**COMMENTS TO THE OICA PROPOSAL (TRANS/WP.29/GRSP/2003/2)
FOR AMENDMENT TO ECE R14**

Prepared by the expert from Germany

Figure 1

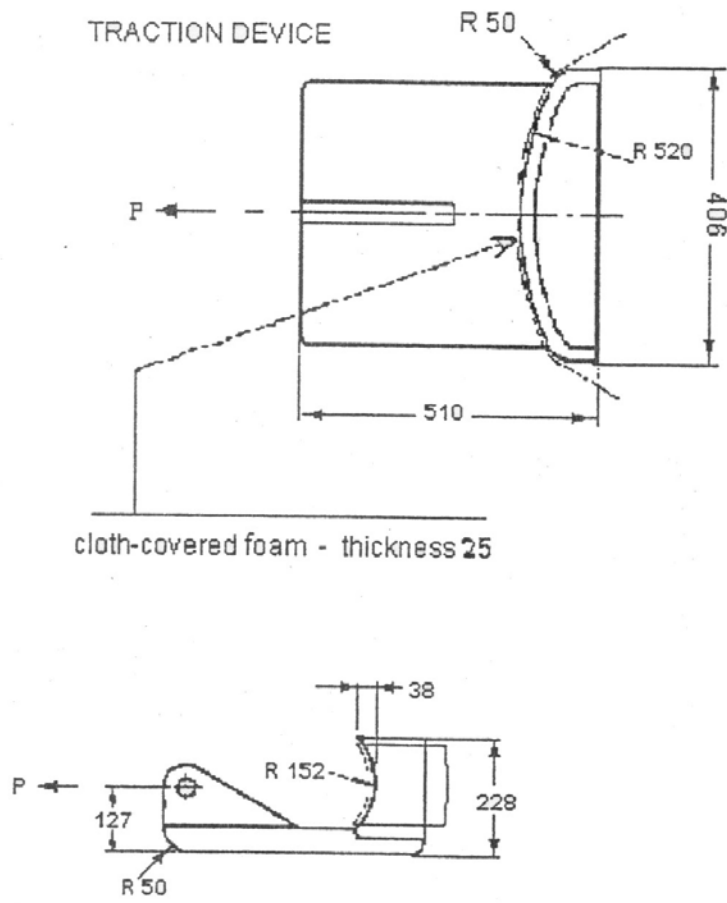
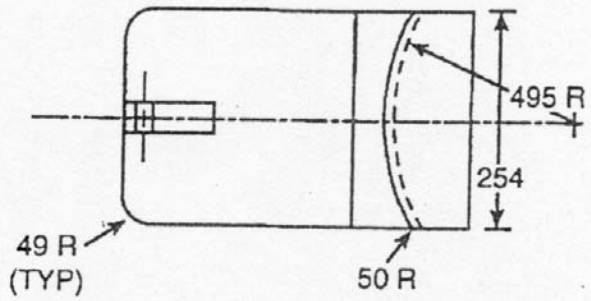
In case of the use of the lap belt traction device it should be allowed to use also the smaller traction device as shown in FMVSS with a width of 10" or 254 mm. This modification is helpful in case of the test of anchorages of a seat bench, where three or four traction devices can not be installed in the tested vehicle. In addition we remember that we have introduced a width of effective anchorages of 240 mm for special seating positions and this can be tested using the smaller traction device too.

Instead of the lap belt traction device a similar device with a width of 254 mm shown in Annex 5 figure 1A may be used also.

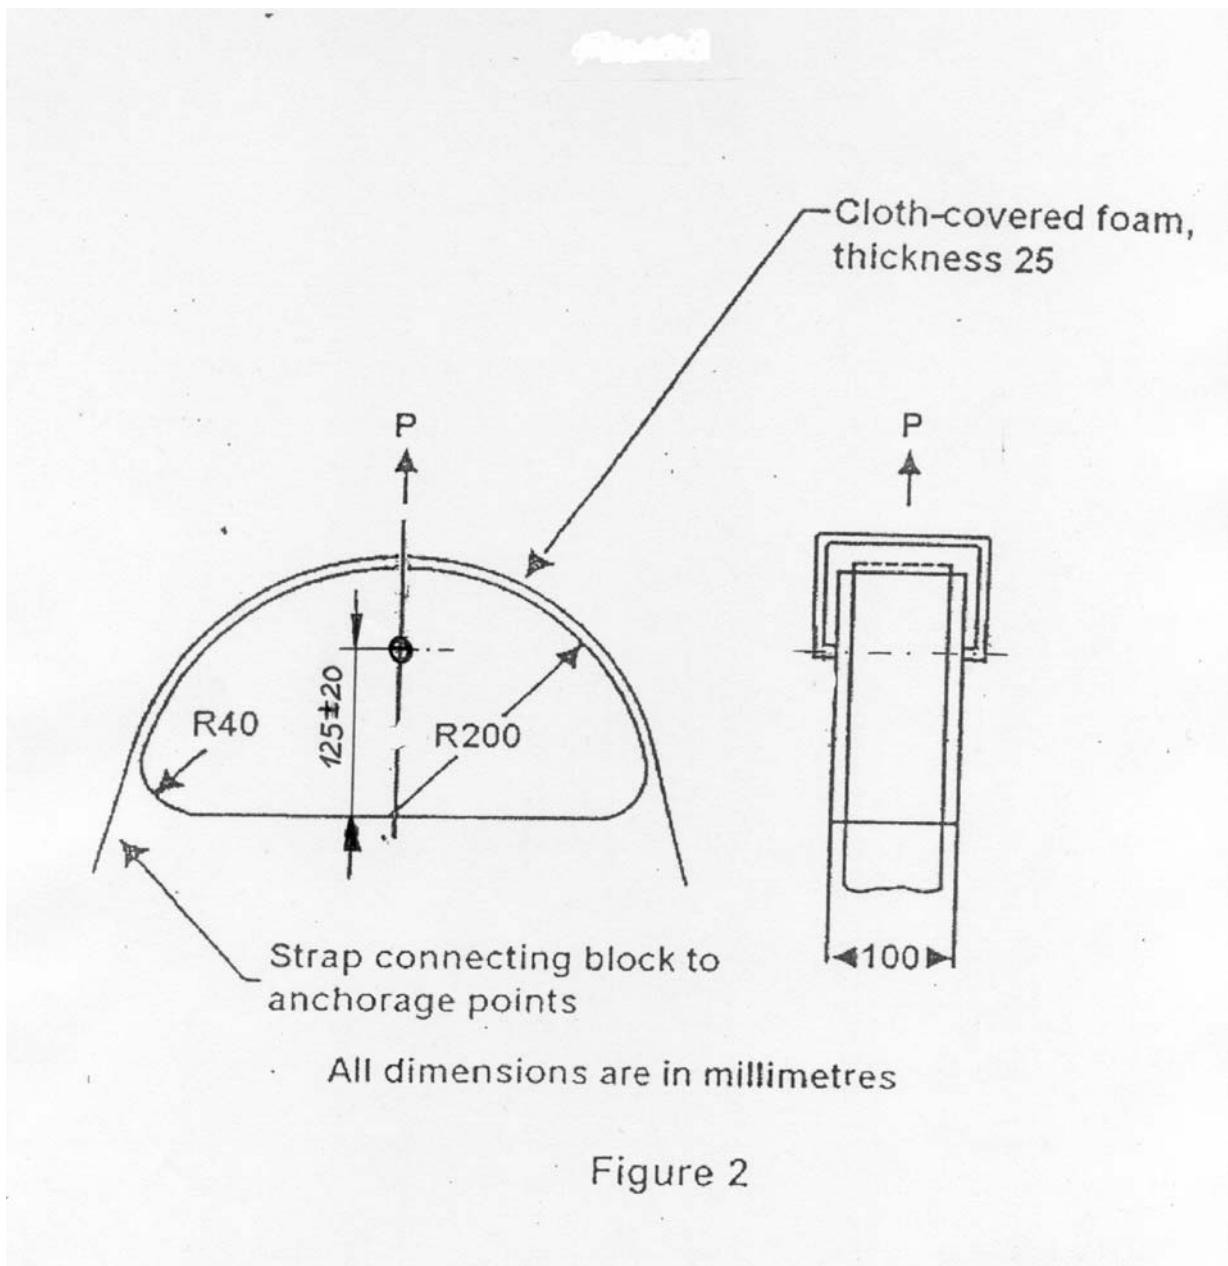
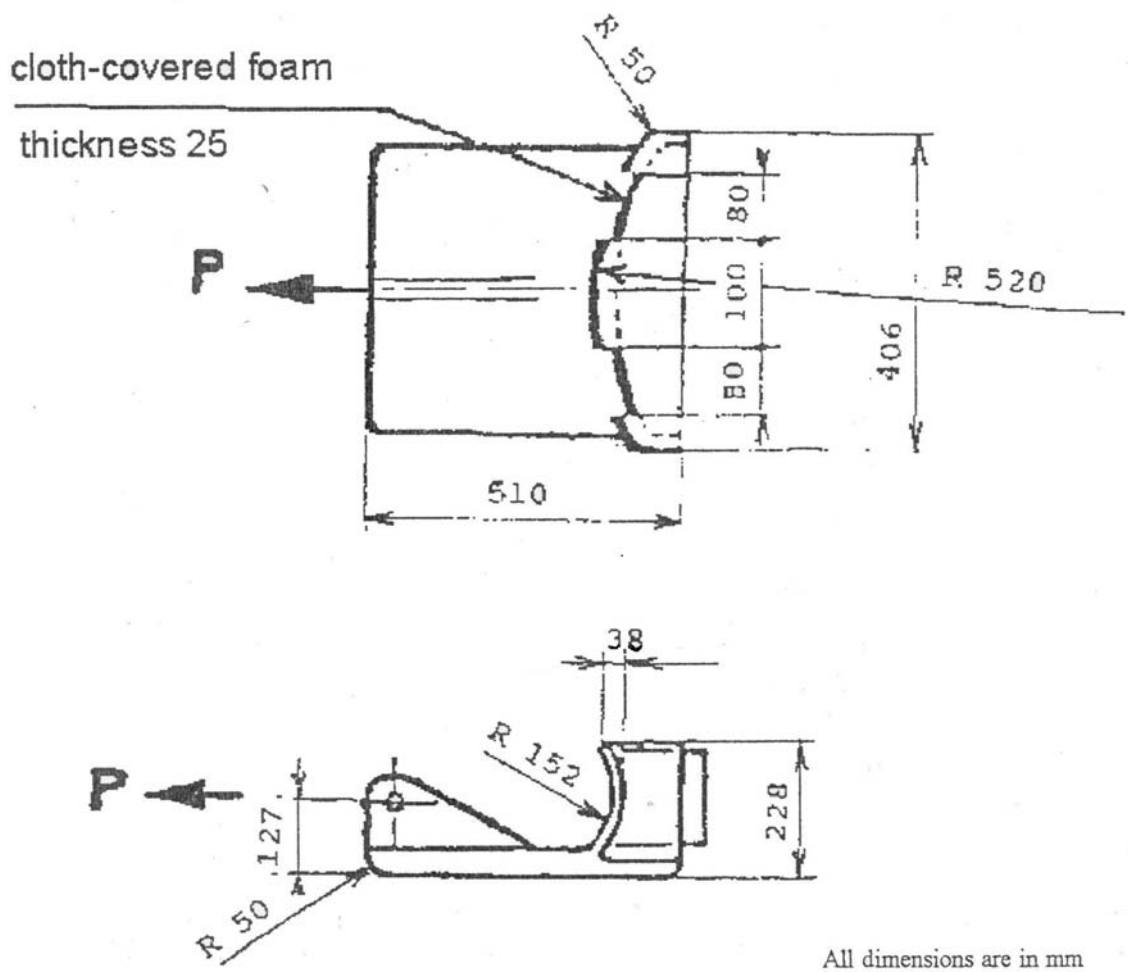
The proposed shoulder belt traction device with a hole, located 65 mm from the rear side leads to an unstable situation during the pull test and the traction device will change the position during the test. The reproducibility of the test is not so good and therefore we recommend locating the pivot point 125 mm from the rear face of the traction device.

For a proper fixing of the strap and to avoid any drop off of the straps during the pull test, it may be permitted to add two land edges and /or bolts to the shoulder belt traction device .

Amend to specify the position for applying the force (i.e. 125 ±20 mm from the rear face).

For the fixing of the strap the shoulder belt traction device may be modified by adding of two land edges and /or some bolts to avoid any drop off of the strap during the pull test.
